Installation of an additional bracket 5St122

1. Derig the glider and remove the baggage compartment floor and back cover plate
2. Instruction 2 of TN1000/12 according to working instruction No. 2 for TN1000/12 must be executed first if required.

drawing No. 1

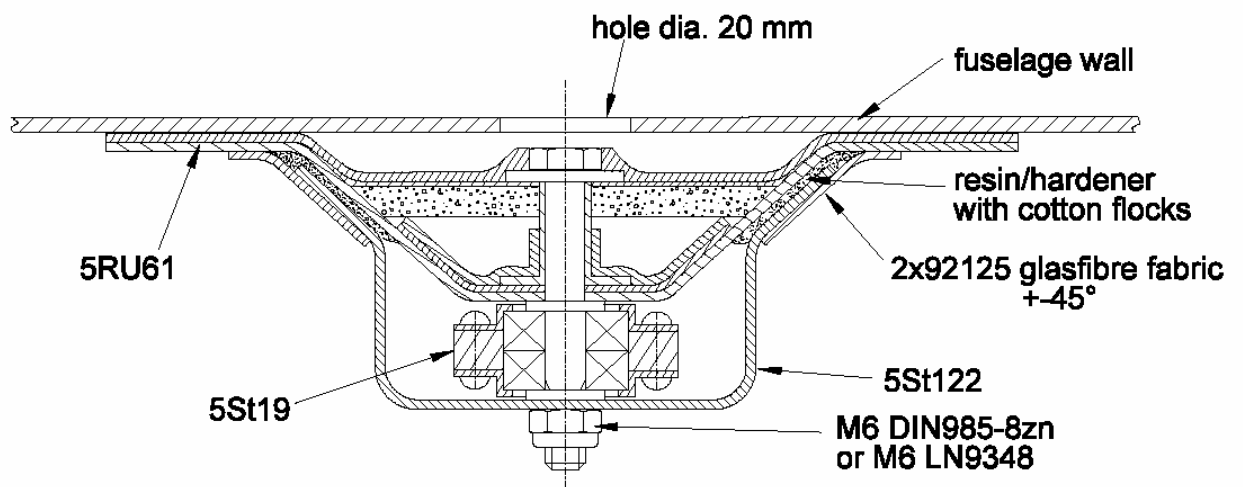
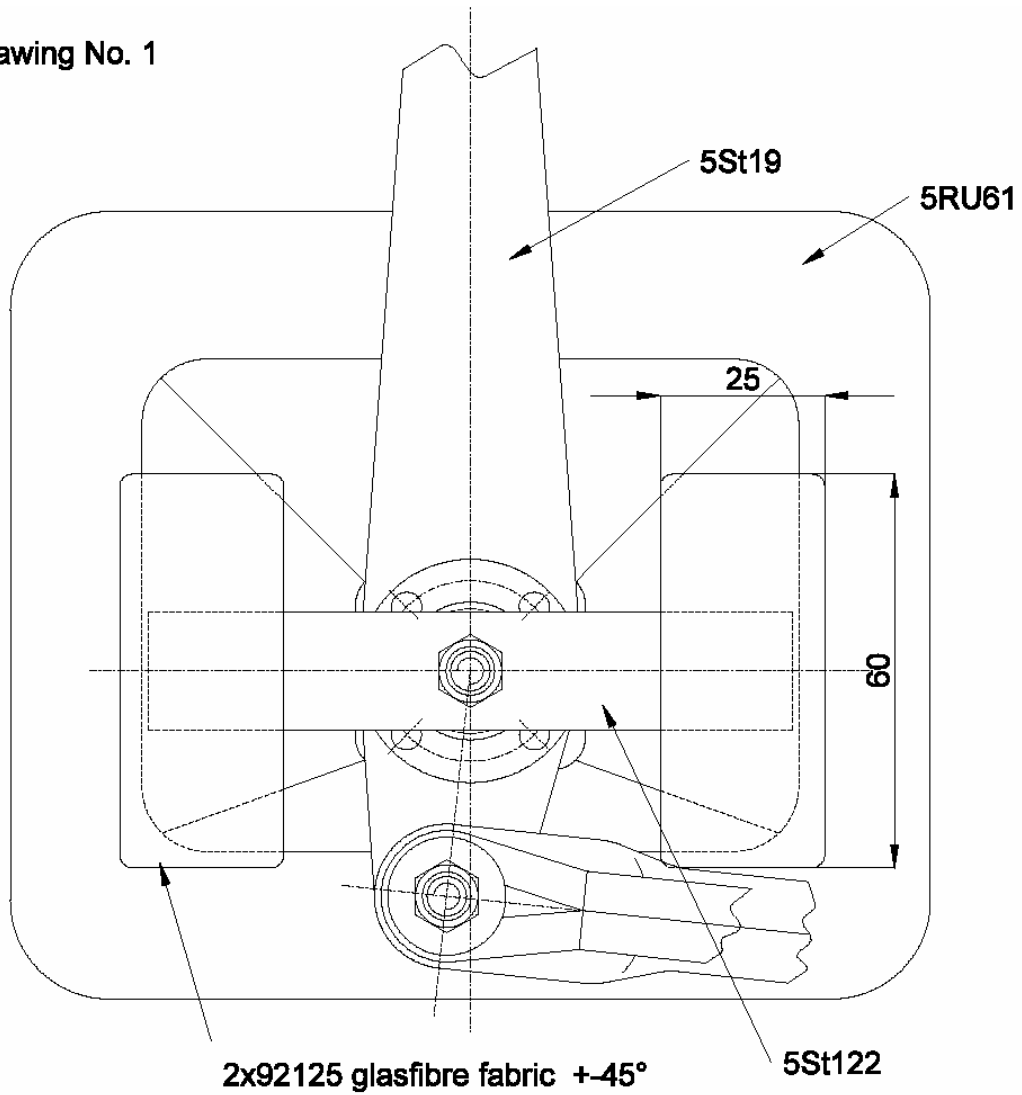
3. Identify the bellcrank 5St19 referring to diagram 1 of the maintenance manual. Remove the bellcrank.
4. Grind the gluing surfaces for part 5St122 at the bearing stand 5RU61 according to drawing 1 with abrasive paper 120 grit.

5. Grind the flanges of part 5St122 at all sides with abrasive paper 120 grit.
6. Install the bracket according to drawing 1 for a trial fit. Rotate the bracket so that the bellcrank has the same free play to the bracket in the full nose down and taildown control positions. Mark this position on the bearing stand and remove the bracket.

8. Install the bracket according to drawing 1 in the marked position. The gap between the flanges of the bracket and the bearing stand must be filled with resin/cottonflock-mixture.

9. Fix the flanges with 2 layers of glassfibre fabric 92125 $\pm 45^\circ$ 25 x 50 mm (1 in. x 2 in.) wide to the bearing stand 5RU61.
10. Let cure at room temperature for min. 12 hours.
